City of Rochester

PLANNING COMMISSON REGULAR MEETING AGENDA

400 Sixth Street	December 1, 2025	7:00 PM
-------------------------	-------------------------	----------------

Subject: Brillati Family Office/134 S. Main Development Project; Preliminary Plan Review #2; Revised site plan set dated 11/7/2025.

2 WEST ELEVATION
SCALE: 3/16" = 1'-0"

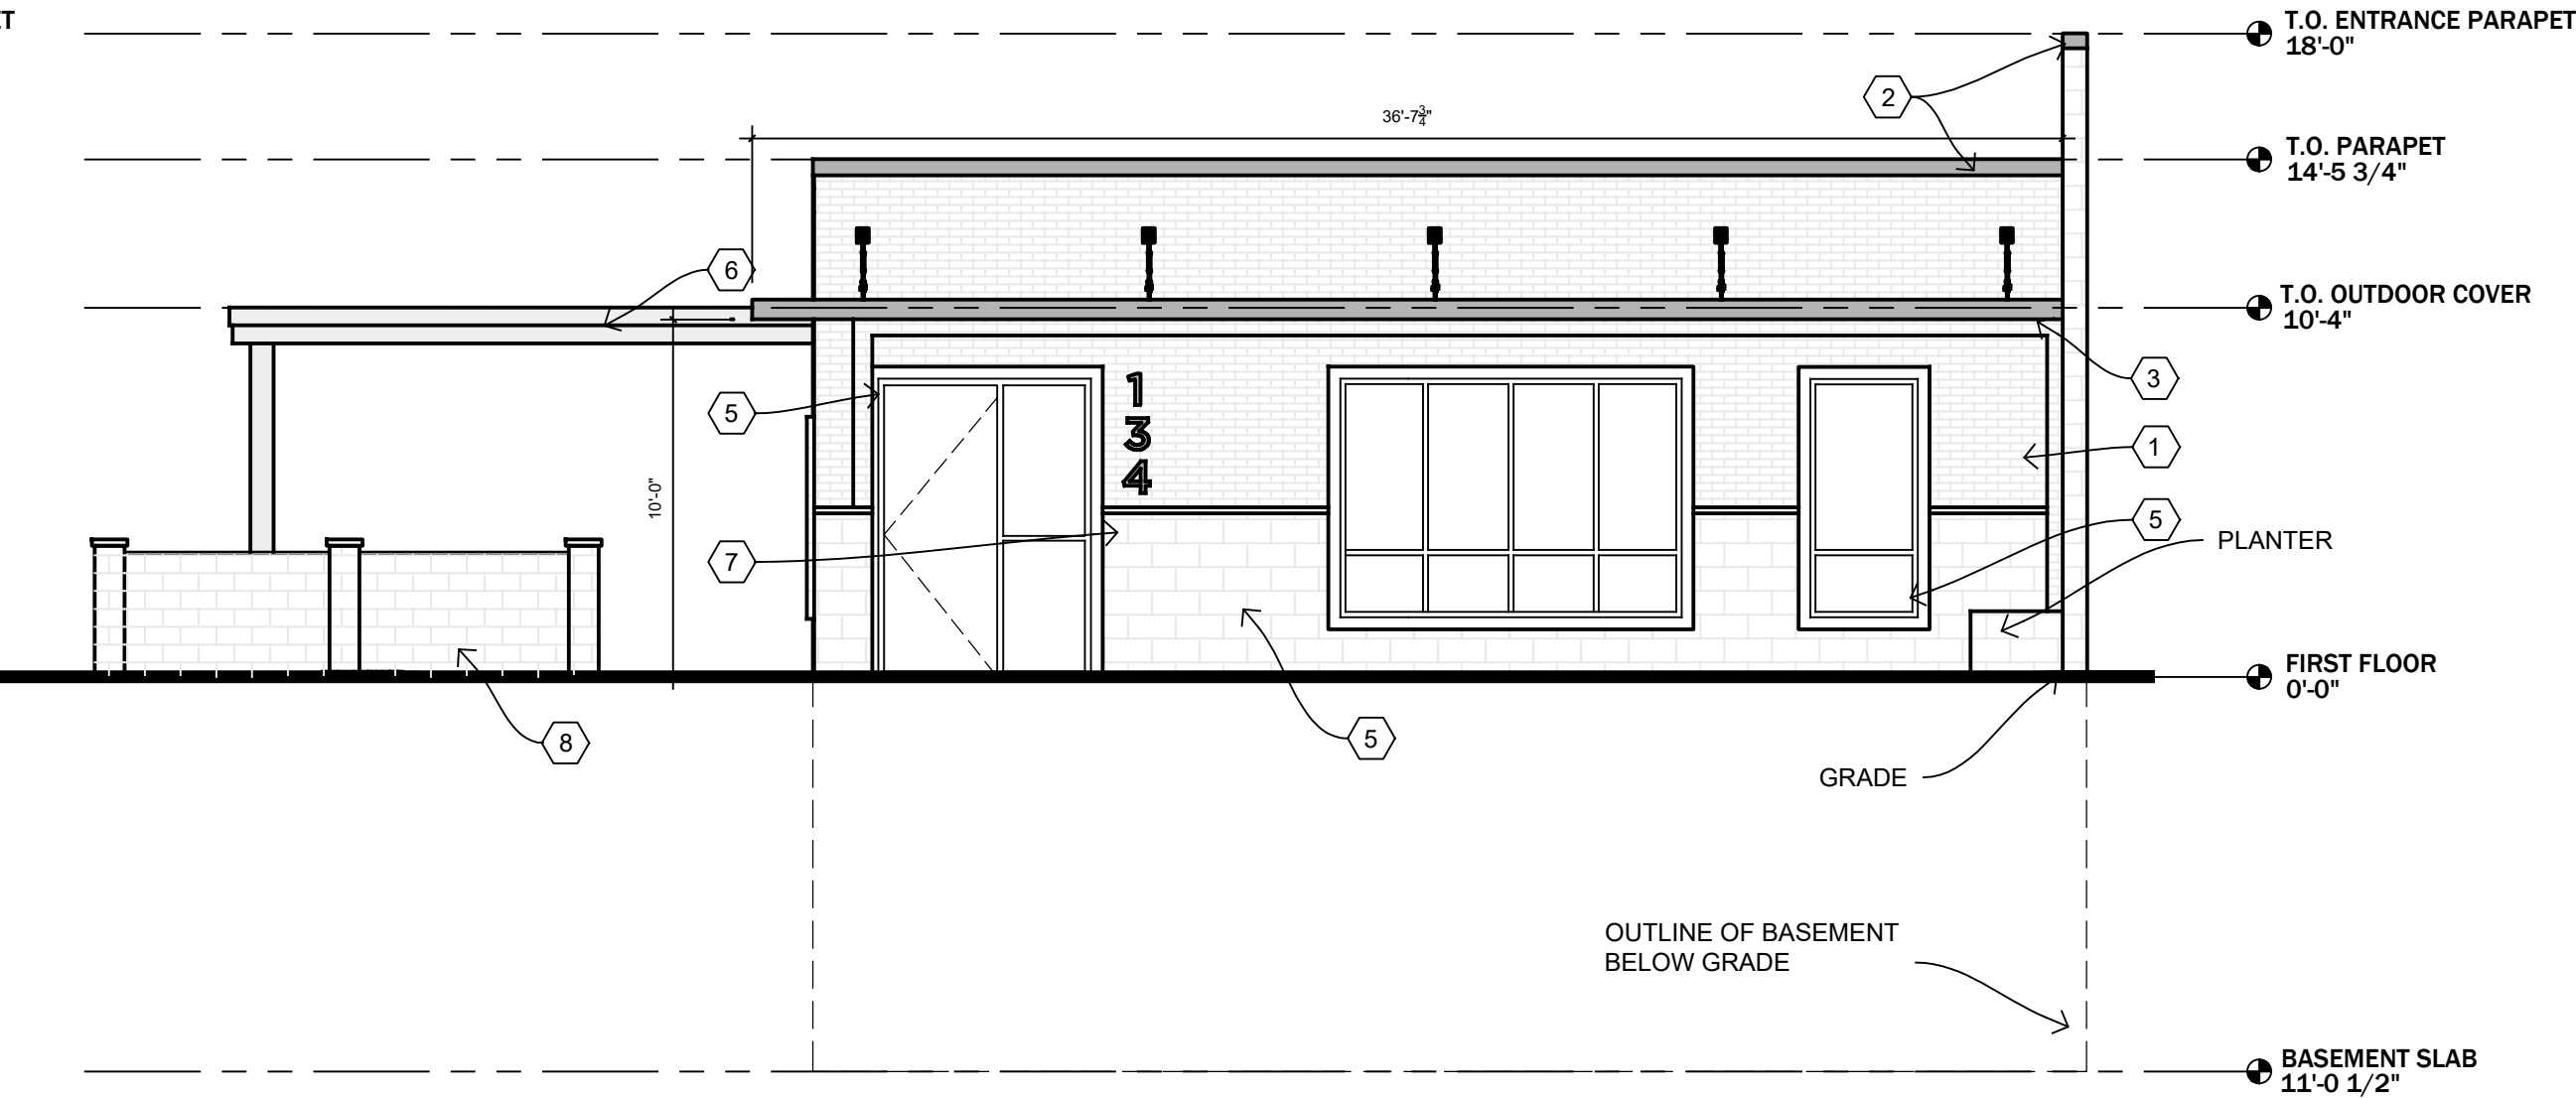
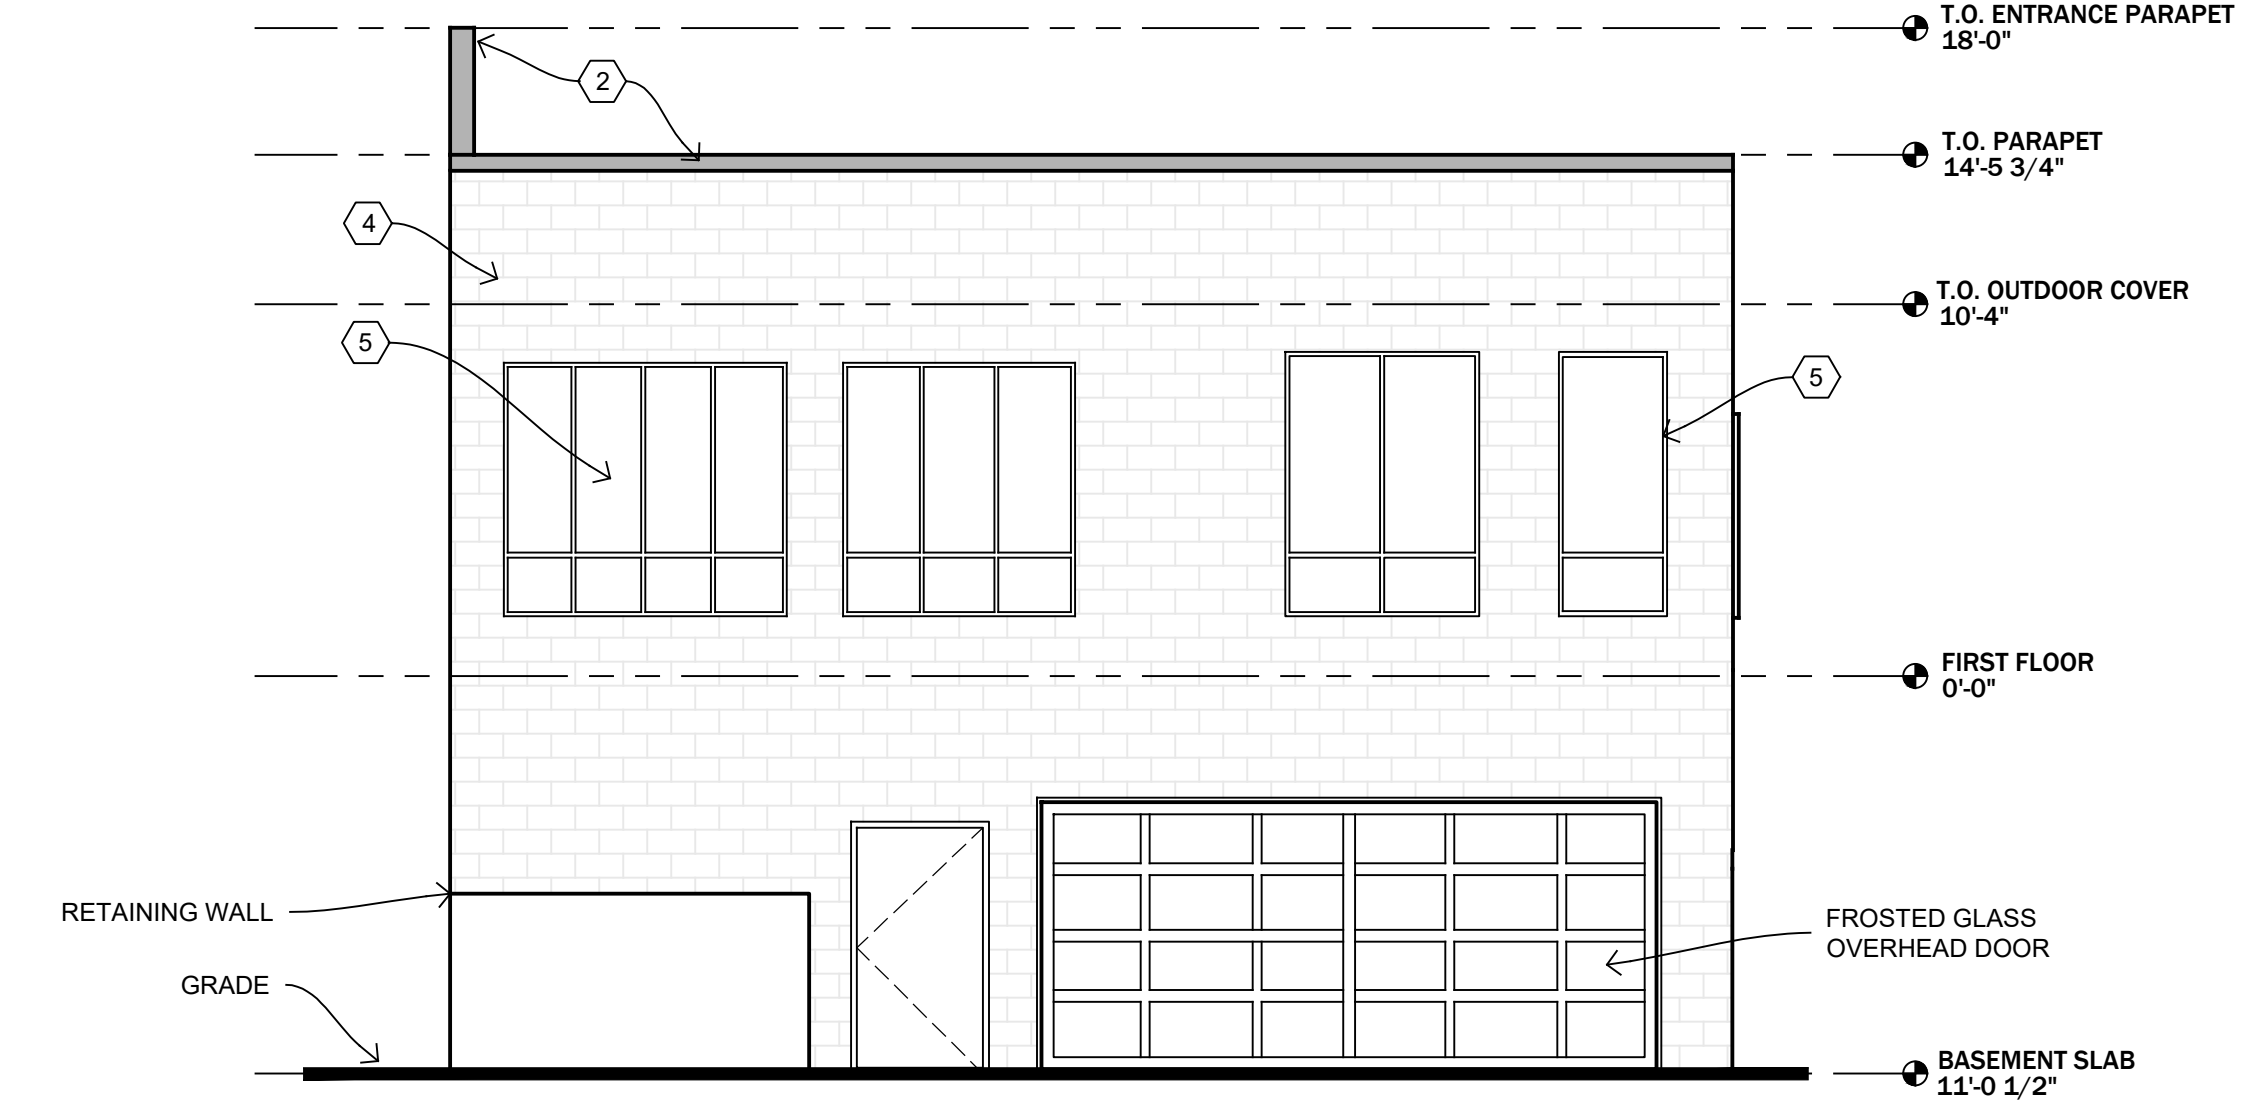
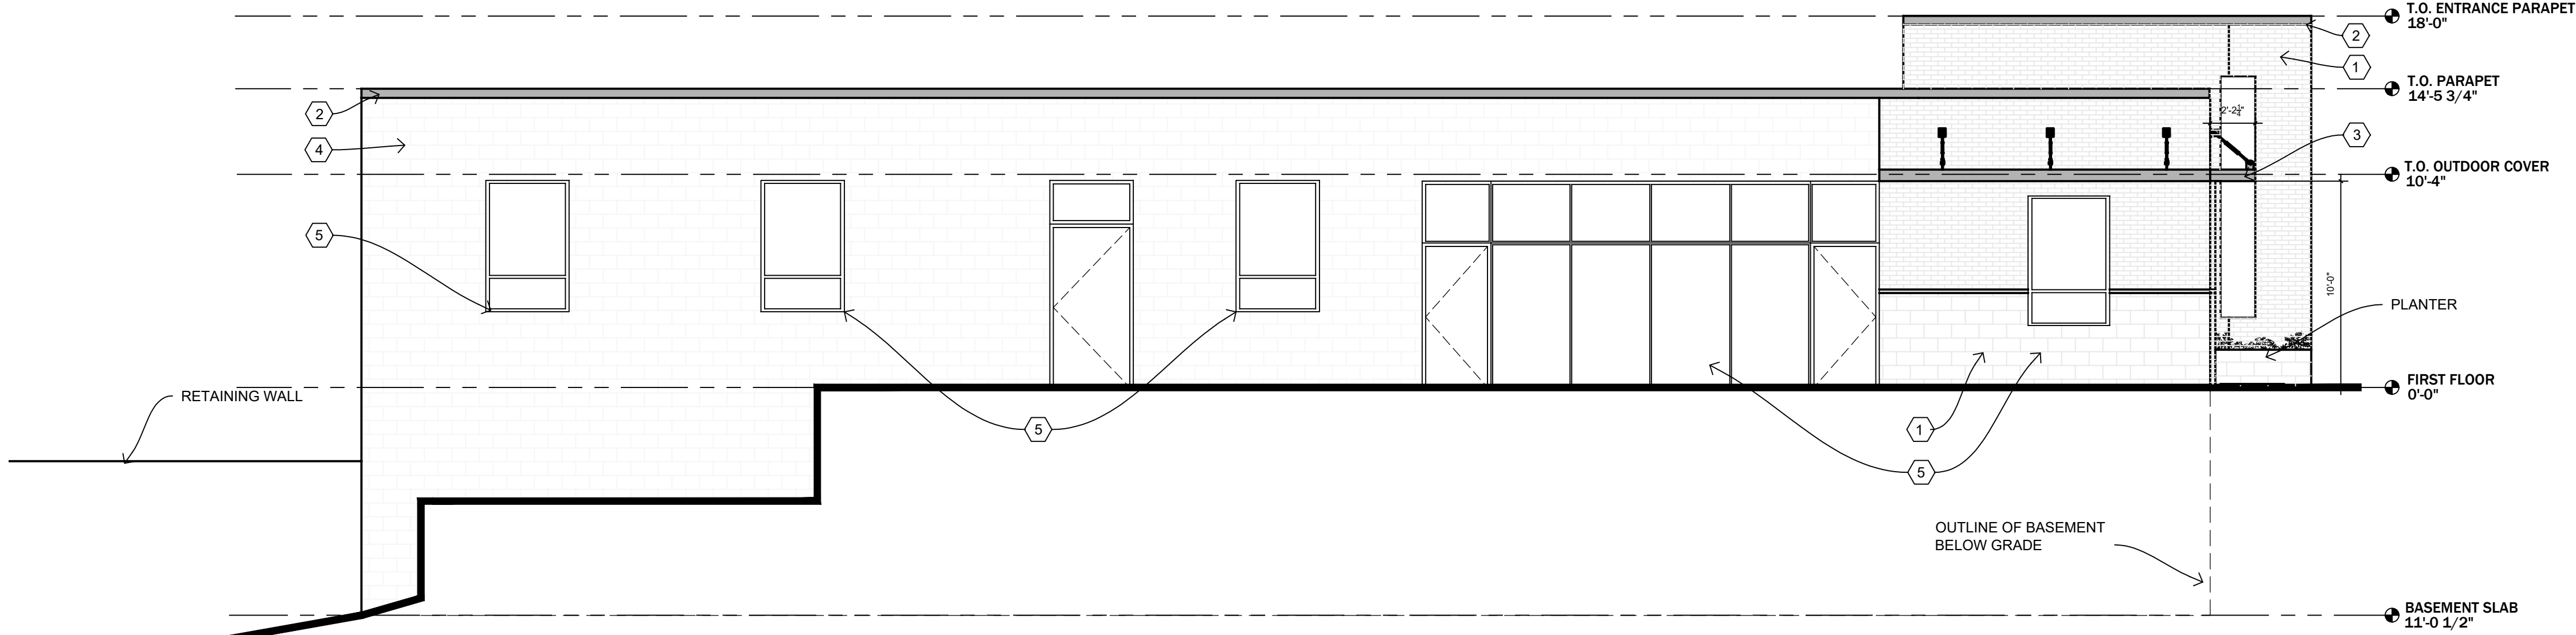
9. The existing building is constructed of CMU blocks and is in a state of disrepair. The applicant proposes to retain the block and add a façade of cast limestone and brick to the west (front) and north facades. The colors are beige/earth tones with black trim and accents. The proposed architecture creates an attractive west and north façade; however, the south façade is a large blank masonry wall and is visible upon entering the Downtown.

We had previously recommended that the applicant consider adding a band of the primary building material across the south façade or add faux windows with spandrel glass or other designs to provide visual relief to this façade and demonstrate compliance with Section 2118 (1) of the Zoning ordinance.

The applicant has responded that the south facade will only be repaired and painted. Addition of some brick or limestone detailing on the south façade will greatly enhance its appearance on par with the proposed upgrade on the north and west sides. Planning Commission input is sought.
